WORK CHANGE DIRECTIVE (WCD) NO. 3

| PROJECT: | ED1503 – Park Avenue from Wil | lkins Street to Eas | st Main S | Stree | t | |
| OWNER: | City of League City | | | | | |

Description: Service Relocation/Modification, Additional conduit and wiring,

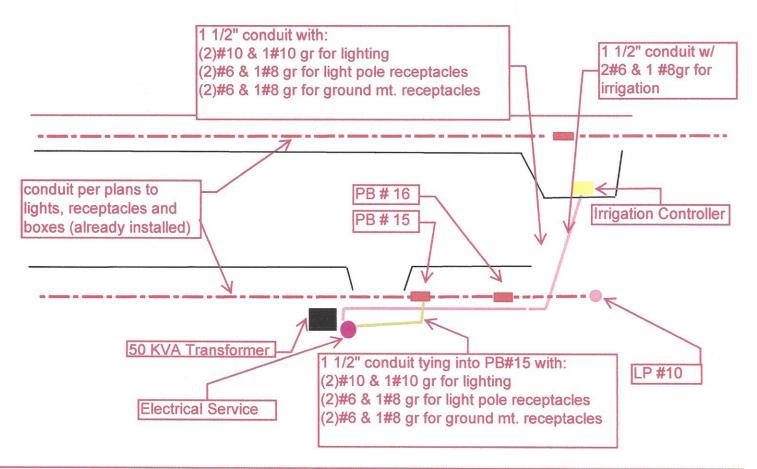
Pfeiffer and Son is proposing to install (3) 1 1/2" PVC conduits from the new service location to:

* Service-electrical panel to PB #15 where the circuits will split off for lighting and receptacles as shown above
* Service-electrical panel to location where (2) 4" PVC sleeves were previously installed. Using sleeving, push (2)
1 1/2" PVC conduit across roadway and tie into irrigation controller with 1 conduit, and tie into PB#11 with the other 1 1/2" PVC conduit. Circuits will split off for lighting, receptacles, and irrigation controller as shown above
*Calculations for lighting are based off of using 240V power with 2 circuits (5 on each)

*Calculations for receptacles are based off the original drawing showing circuits of #6 wire.

*Pfeiffer and Son has Broken out the GFI pole mounted receptacle into a separate circuit of #6 wires.
